T046 - Replacement of VAC3 & VAC4 Vacuum Pumps (M0358MS/M0359MS)

Jan 2021 (v2.0)

Conversion

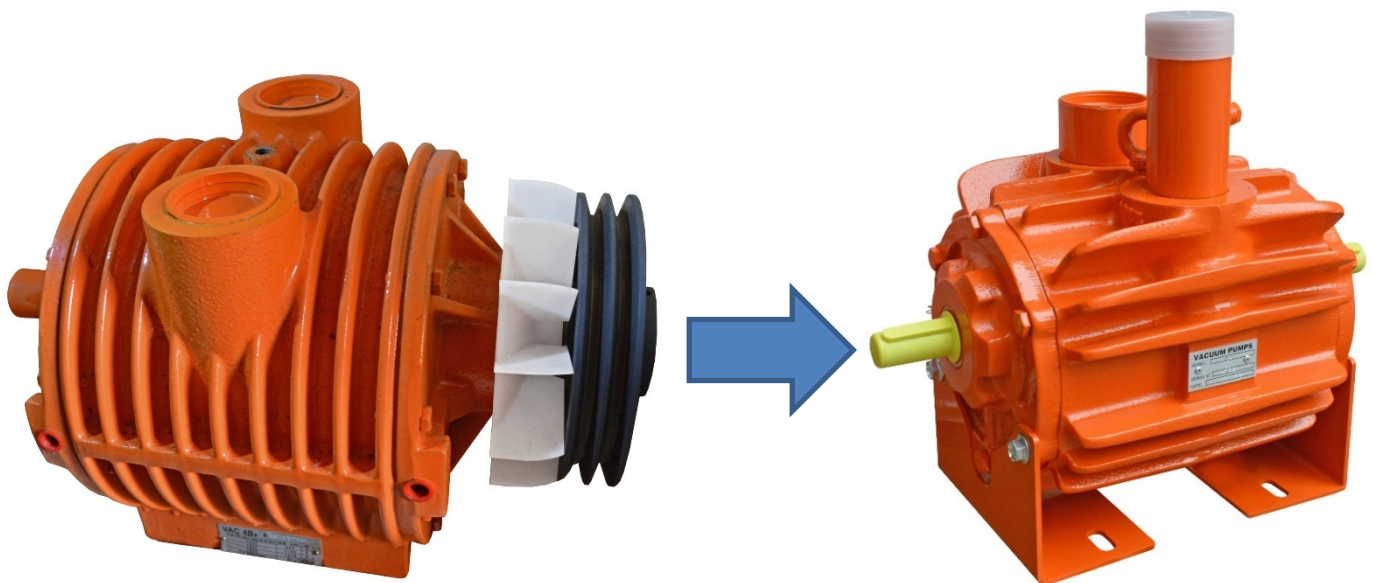
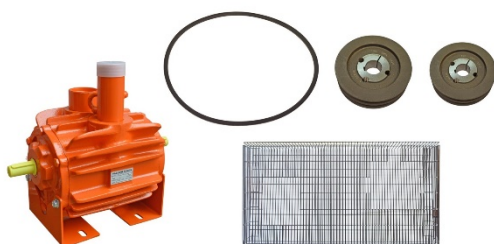
The ISO pumps Vac3A and Vac4B are no longer available from Gascoigne Melotte. Replacements vacuum pump kits are available from Milking Solutions that use the same foot bolts and vertical ports, for easy replacement.

Vac3A is replaced by kit M0400MS (VP1500; 1100 Lt/min)

Vac4B is replaced by kit M0399MS (VP2200; 1800 Lt/min)

The following are included within the kits to replace existing parts;

M0400MS

Guard M0360MS

Pump Pulley 150x24x1

Motor Pulley 112x28x1

Belt 1x B44

Pump M0358MS

M0399MS

Guard M0360MS

Pump Pulley 150x24x2

Motor Pulley 115x28x2

Belts 2x B50

Pump M0359MS
